## PRODUCT SERVICE BULLETIN

### **FIX AS FAIL: B/BX-Series; Oil Leakage From Loader Quick Coupler**

**Product Line:** B/BX-Series

(15) Old Cartridge  
(16) New Cartridge

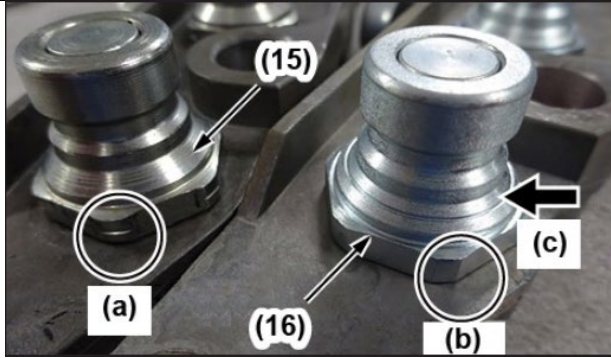
Loader Quick Coupler leakage has been noted after the tractor has been sitting for a day or more under low oil pressure.

The wholegoods kits affected are not serialized; this issue only applies to wholegood kits containing the old-style couplers. Please see the below image for examples of the old-style vs. new-style to determine if this bulletin applies.

(a) Notch in Hex.  
(b) No Notch in Hex.  
(c) Groove on surface
